Item ID: D212-664-201

Item Name: Crosstube Aft

DART SERVICE INSTRUCTION

DRAWING NO. D212-664-241	TITLE CROSSTUBE ASSY (205/212 HI AFT)	REV. D	DART AEROSPACE LTD ENGINEERING ORDER		D.E.O. NO. D212-664-241-D-1	SHEET NO. SHEET 1 OF 2	SCALE NTS
DRAWN	CHECKED	MFG. APPR.	APPROVED	DE APPR.			
DATE 11.04.07	DATE 11.04.11	DATE 11.04.12	DATE 11/04/12	DATE 11.04.12

FIGURE 1: SUPPORT INSTALLATION

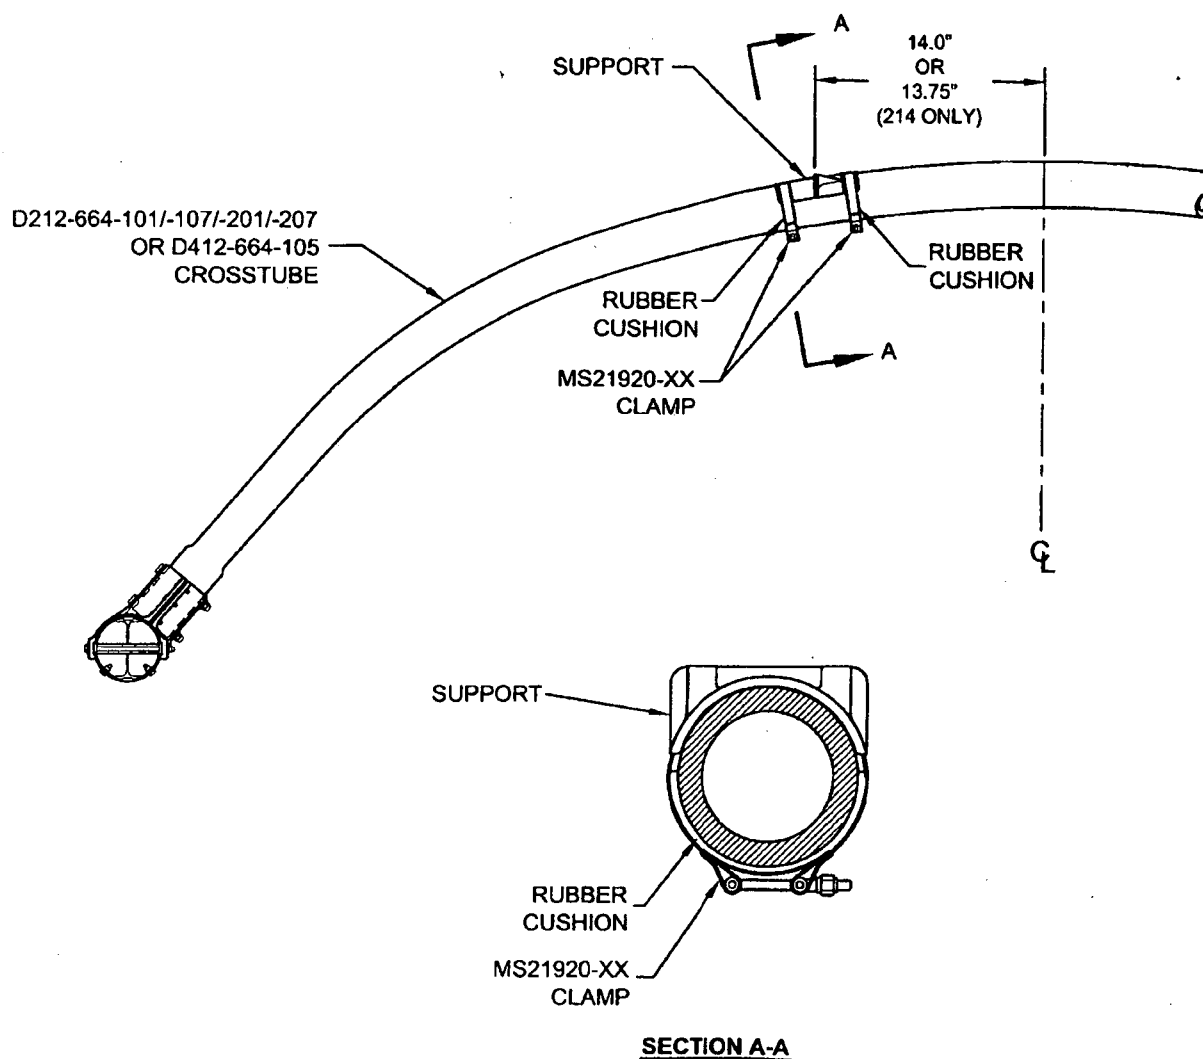
The supports on the following crosstubes are now installed using Proseal instead of Magnobond:

For the crosstubes listed above, section 32.4 of ICA-D212-664 is amended as follows. Use Figure 1 of this service instruction and Figures 32-2 to 32-9 of ICA-D212-664 for further reference. For crosstubes of an earlier change number, it is recommended that if the supports are removed, the supports should be reinstalled using the procedure listed below.

- 32.4.5 Apply a 0.04" to 0.07" thick layer of Proseal 890 Class B or AMS-S-8802 Class B sealant underneath applicable support and install support as shown in Figure 1 of this service instruction.

- 32.4.6 Install the clamps opposite to crosstube support as shown in section A-A of Figure 1. Install rubber cushions underneath each clamp around the bottom circumference of the crosstube up to the crosstube centerline. Torque clamps 80-100 in-lb (9.0-11.3 Nm). It is acceptable to use smaller or larger sized MS21920-XX clamps than those listed in ICA-D212-664, ensure that after torquing the clamps per this instruction, the nuts are in safety but not bottomed out

**D212-664-241/-241B
ASSEMBLY DETAIL**

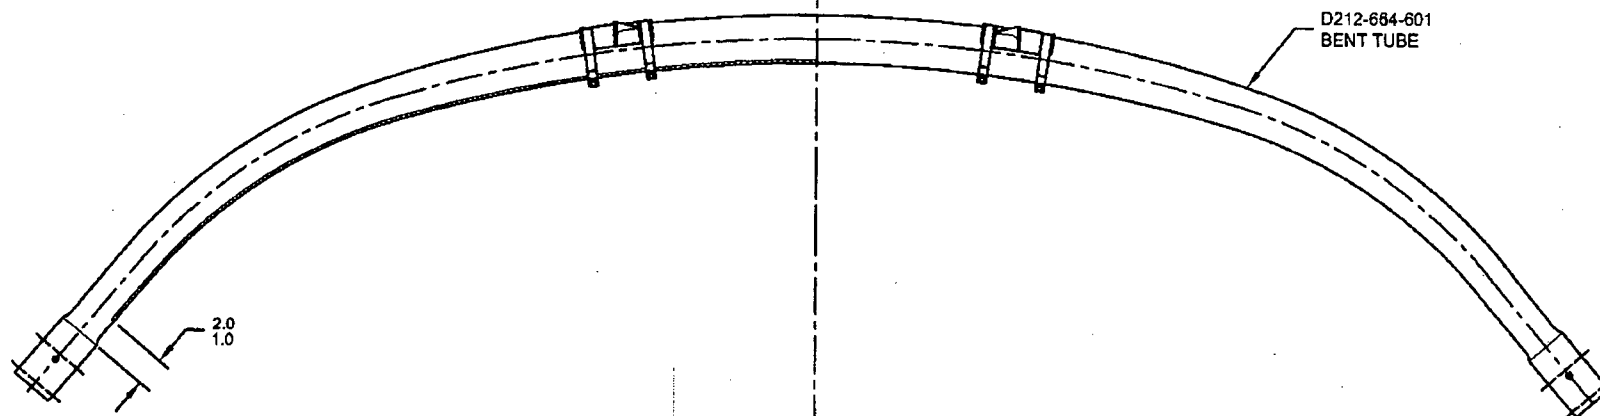
ADD AN INSPECTION WINDOW TO UNDERSIDE OF CROSSTUBE.

NOTES 2 OF SHEET 1 IS AMENDED AS FOLLOWS:

- 2) FINISH: CHEMICAL CONVERSION COAT PER DART QSI 005 4.1
PRIME INSIDE AND OUTSIDE PER DART QSI 005 4.2
MASK UNDERSIDE OF CROSSTUBE AS SHOWN (HATCHED AREA) AND
PAINT OUTSIDE PER DART QSI 005 4.2
REMOVE MASKING AND APPLY CLEAR COAT

MASK AREA PRIOR TO PAINTING,
REMOVE MASKING AFTER PAINT
AND APPLY CLEAR COAT

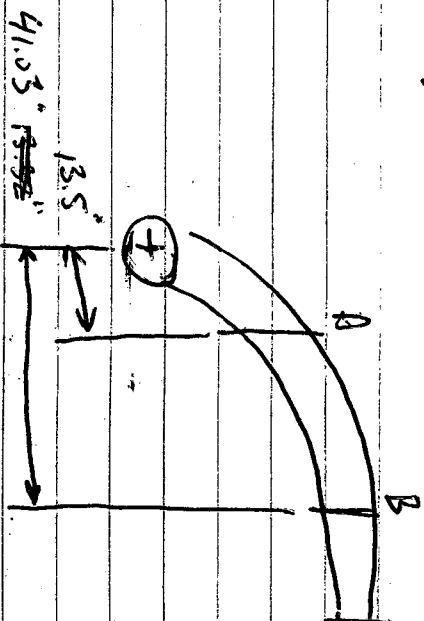
REPLACE MAGNOBOND WITH PROSEAL.

NOTE 12 & 15, SHEET 1 IS AMENDED AS FOLLOWS:

- 12) TO INSTALL D2940-1 SUPPORT: ABRASE MATING SURFACE OF SUPPORT AND CROSSTUBE WITH 180-GRIT SANDPAPER AND REMOVE RESIDUE WITH MEK (OR EQUIVALENT). APPLY A 0.04" TO 0.07" THICK LAYER OF PROSEAL 890 CLASS B-2 (OR AMS-S-8802 CLASS B-2) SEALANT TO MATING SURFACE OF SUPPORT.
- 15) TORQUE CLAMPS 80 TO 100 IN-LB. ENSURE AT LEAST 1.5 THREADS SHOWING IN SAFETY AND THAT NUT HAS NOT BOTTOMED-OUT AFTER TORQUING. **PRIOR TO PACKAGING, RE-CHECK TORQUE ON CLAMPS AFTER PROSEAL 890 SEALANT HAS CURED FOR 72 HOURS.**
